SUBSURFACE WASTEWATER DISPOSAL SYSTEM APPLICATION

Town or Location: AUGUSTA

Street Subdivision Lot #: 1040A CHURCHILL ROAD

SUBSURFACE WASTEWATER DISPOSAL PLAN

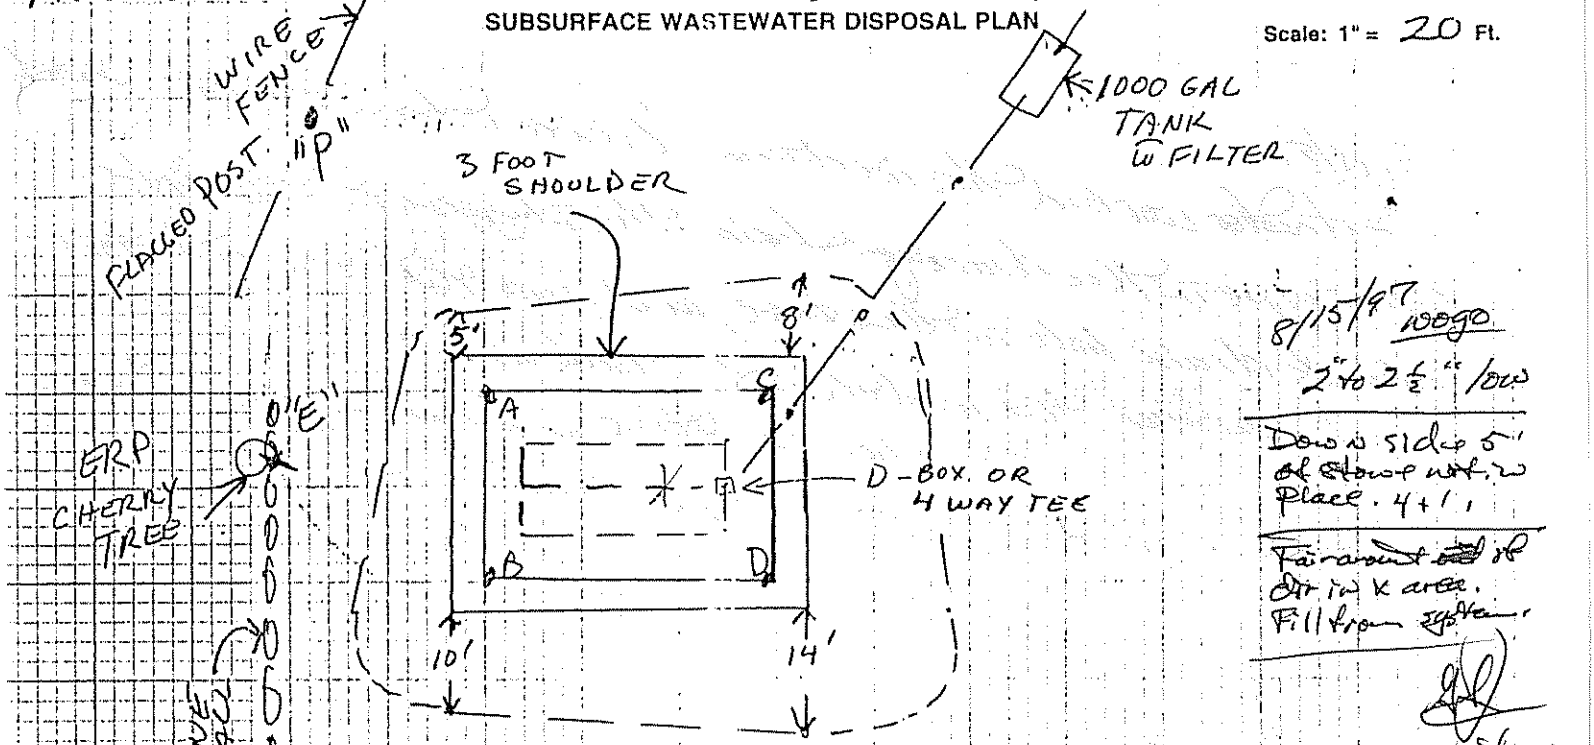
8/15/97 nogo.
2" to 2½" low
Down side 5' of stone wall in place. 4+1'
Fairamount ~~[illegible]~~ of dir in K area. Fill from ~~[illegible]~~.

DISPOSAL AREA CROSS SECTION

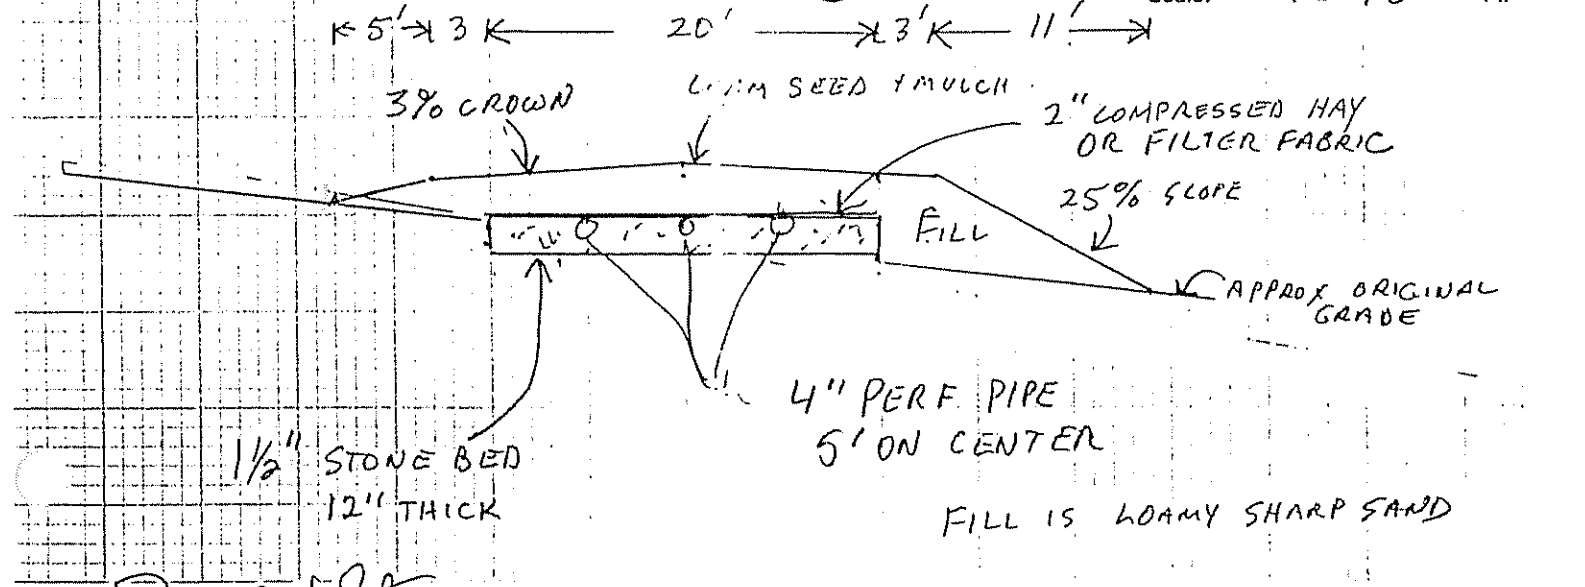
8/18/97
Contractor worked this weekend. Owner witness the raising of the pipe in the drainage field, the plugging of the septic tank drain hole in the base, and said that the contractor had excavated the width of a back hoe on the left side to widen the shoulder stone and had placed 12 inch stone. 8:30 AM. System capped and mulched.
